Detroit
Edison

February 12, 1985
NE-85-0277

Subject: Request for Revision to
Draft Technical Specifications

Detroit Edison requests a change to the draft Fermi 2
Technical Specifications as indicated in Attachment 1.

THE PURPOSE OF THIS PLAN AND SECTION IS TO ILLUSTRATE THE ARRANGEMENT OF THE SURVEY POINTS LISTED IN TABLE 3/4.7.3 -1

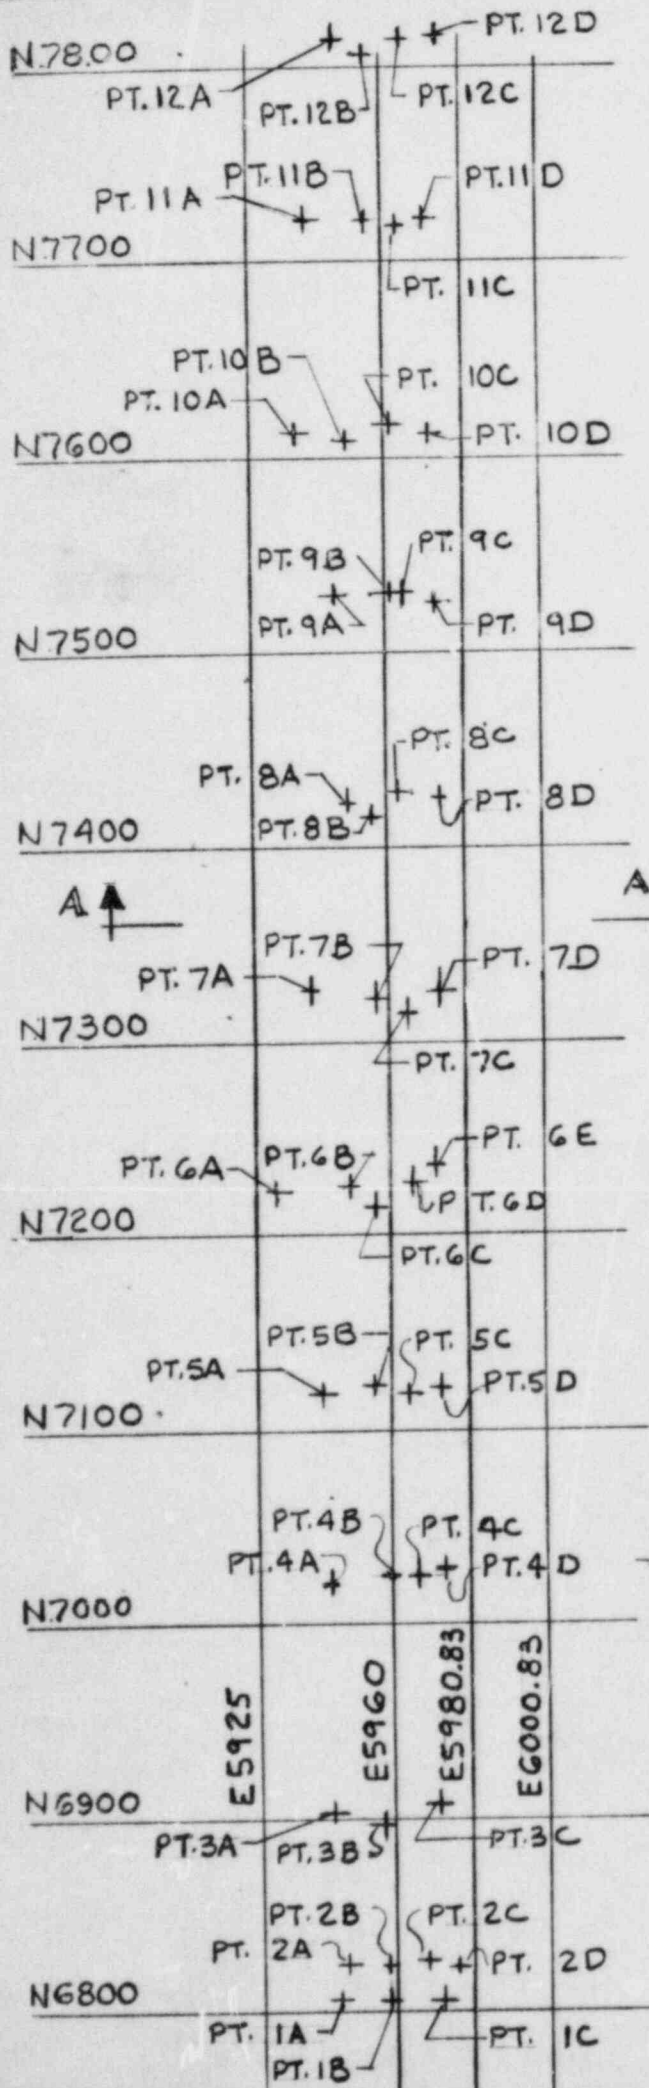
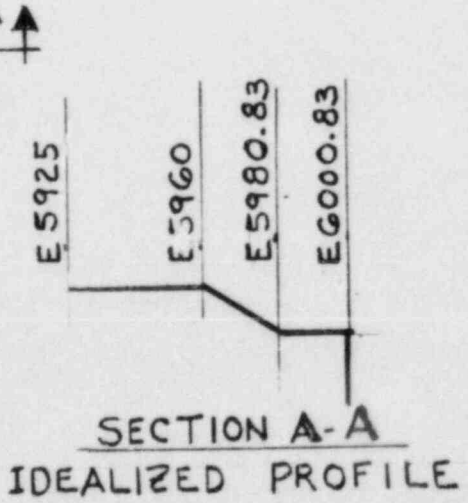
At the request of Mr. Gary Staley of the Environmental and Hydrologic Engineering Branch, Detroit Edison has agreed to modify specification 3.7.3 as indicated in Attachment 1 to include the location and elevation of each survey point on the shore barrier.

3.7.3 The shore barrier shall be structurally sound and capable of limiting wave action as intended. The shore barrier shall be maintained such that the elevation of each survey point listed in Table 3.7.3-1 is not less than 1.0 foot
APPLICABILITY: At all times, below the elevation listed in the table.

ACTION: determined during the 1984 survey (see Table 3.7.3-1)

With the elevation of one or more survey points different by more than 1 foot from the ~~as-built~~ elevation, prepare and submit to the Commission within 90 days, pursuant to Specification 6.9.2, a Special Report which includes the following information:

FIGURE 1
SECONDARY CONTAINMENT RESPONSE
DUE TO A DBA-LOCA

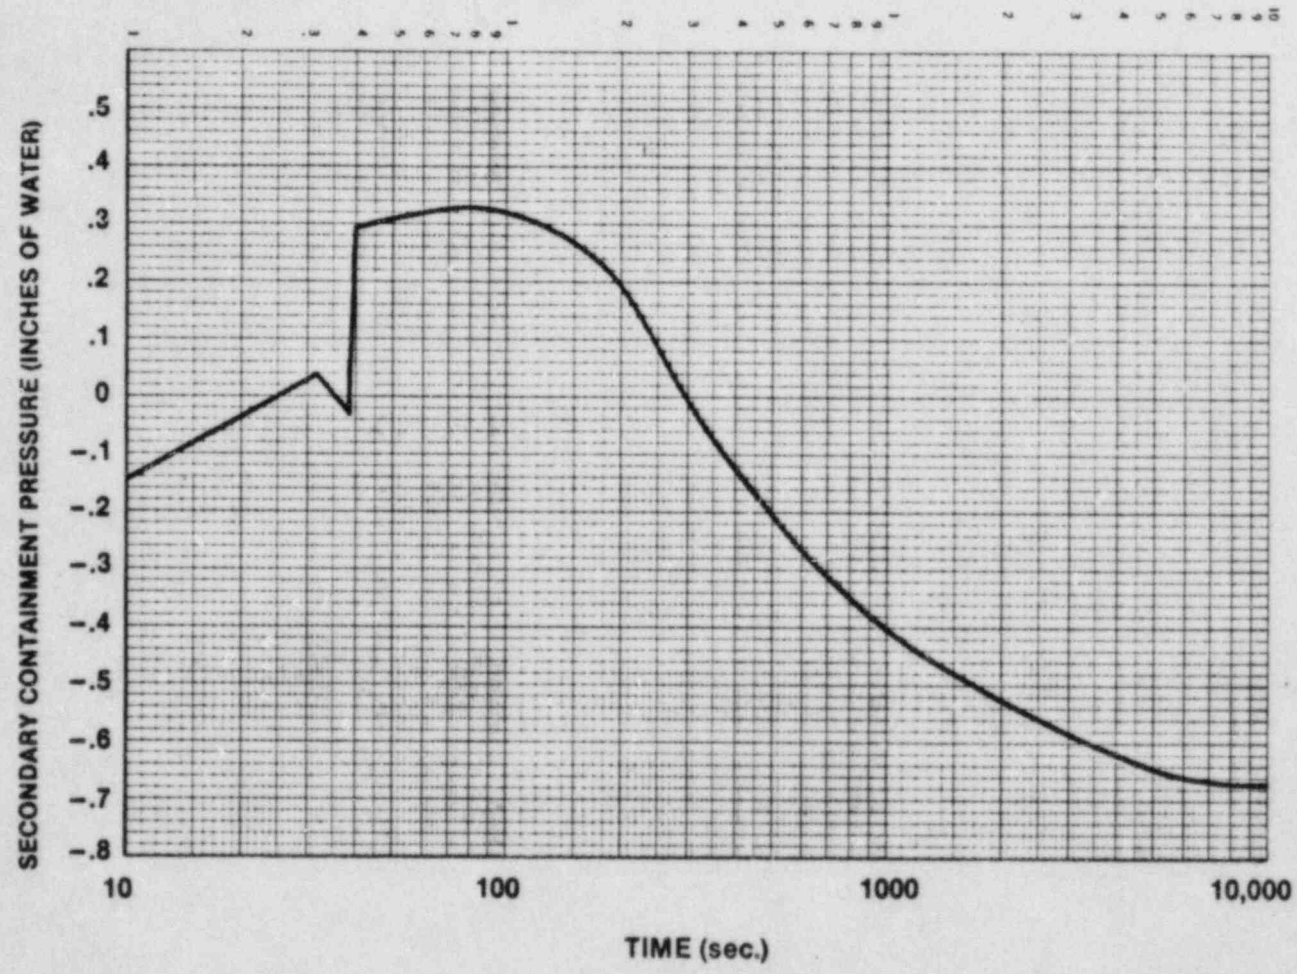
The secondary containment response due to a DBA-LOCA is shown in Figure 1. During the first 33 seconds, the pressure increases to a slightly positive value. With the activation of the SGTS at 33 seconds and the activation of the area coolers at 38 seconds, the pressure decreases to near atmospheric.

At ~~33~~ ³⁶ seconds, pressure-relieving doors on the common wall between the torus room and the corner rooms open and allow heated torus room air to enter the rest of the secondary containment. This step input of heat into the secondary containment appears as a sharp pressure spike on Figure 1.

replace with attached sketch
